PROPOSED ALTERATIONS & ADDITIONS
AT 29 BIMBADEEN CRES. FRENCHS FOREST
FOR MR. & MRS. ABBOTT

SITE & SITE ANALYSIS PLAN & NOTES
Scale 1:200 Date 1.2.18 Drawn by R. Conway
Phone: 0425 314 716 Drg. No. 18/1/4.A

SITE & SITE ANALYSIS PLAN Scale 1:200

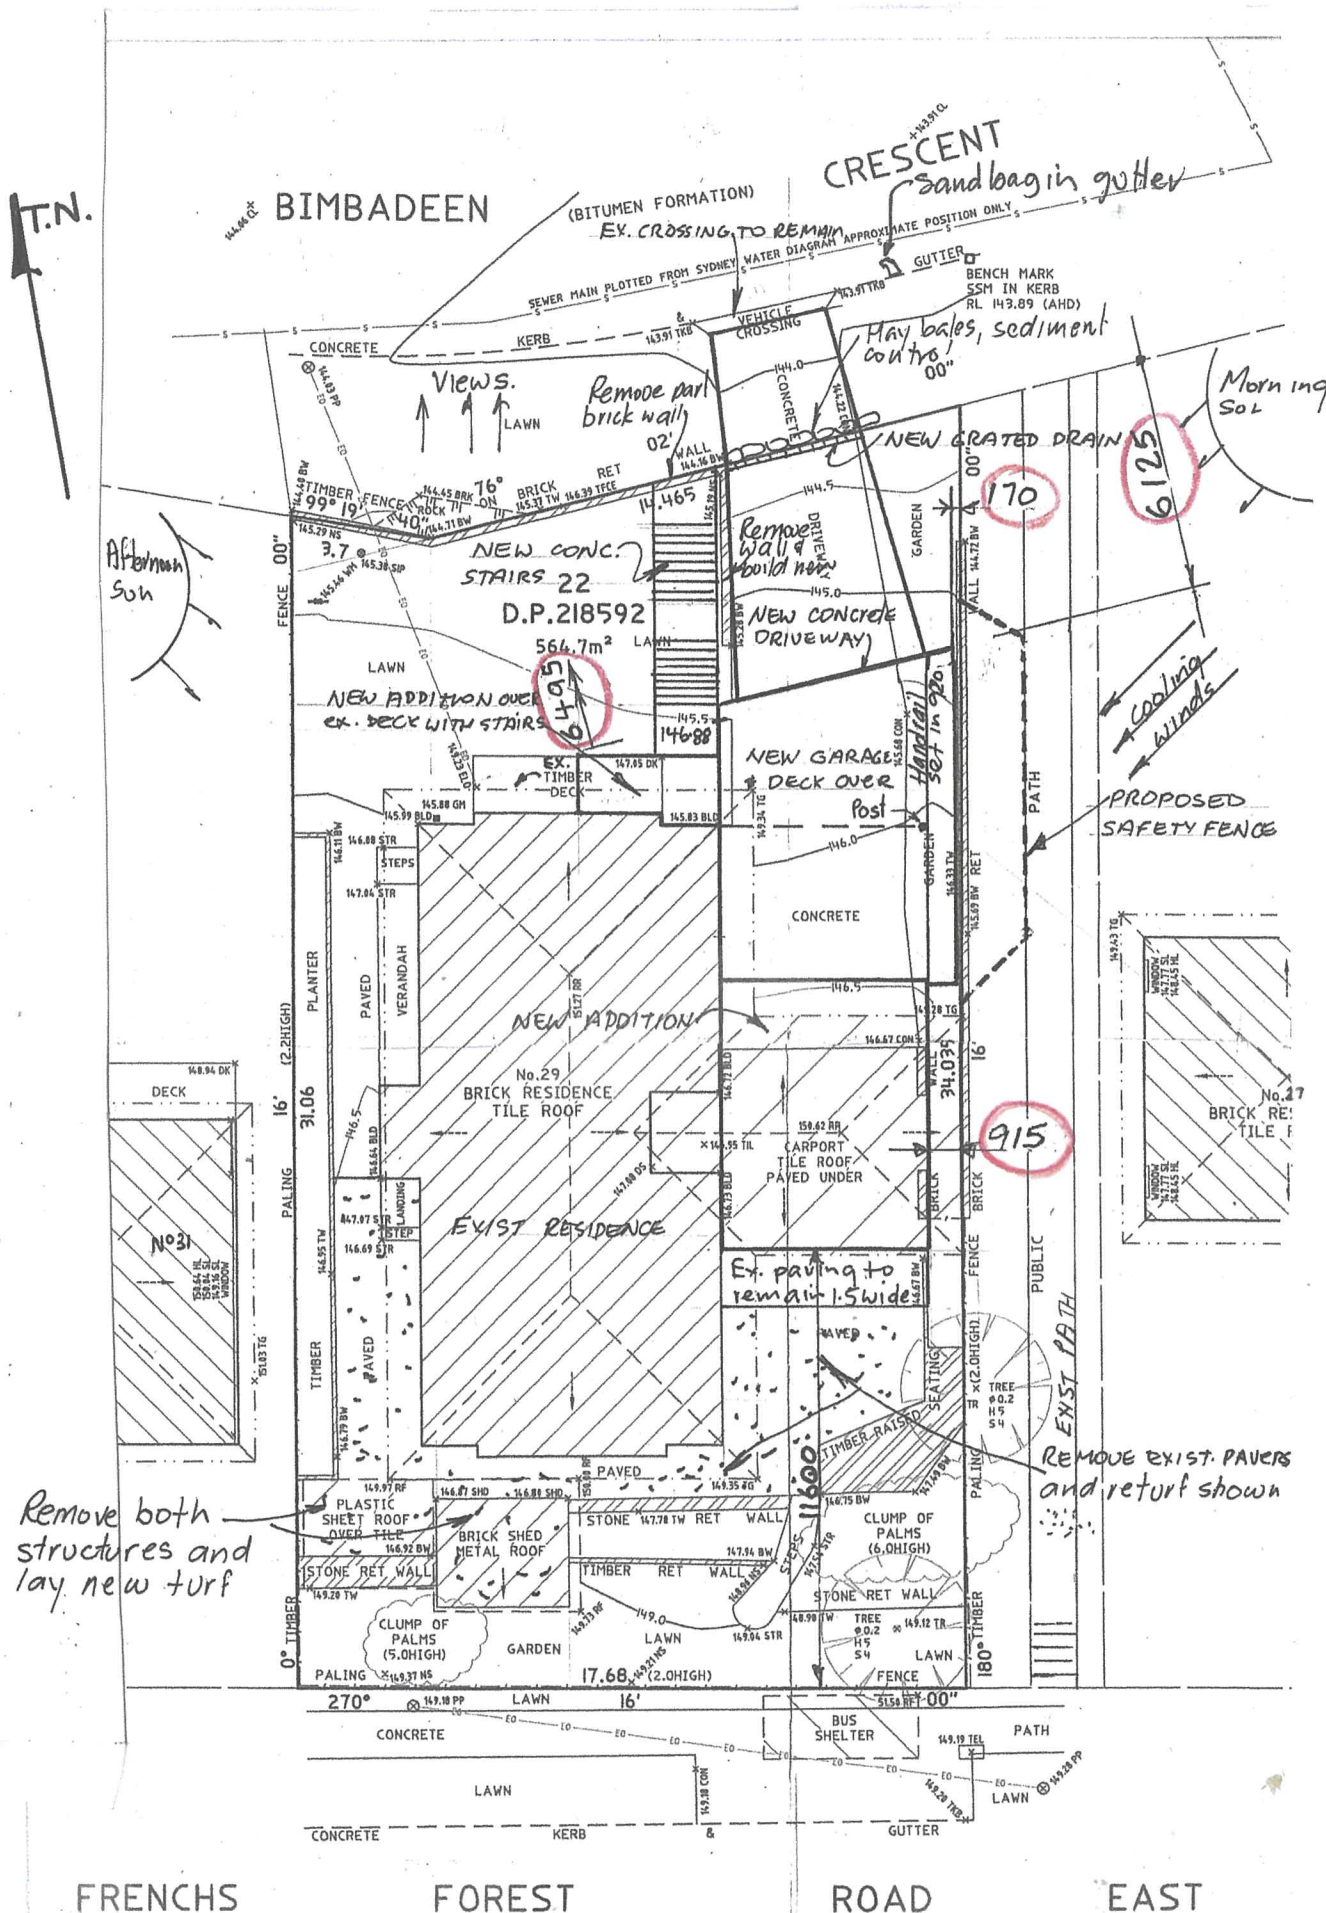
Amendment A by R. Conway. 28.09.2020
Set back dimensions changed after Building Compliance Survey completed.
Modification applied for changes.
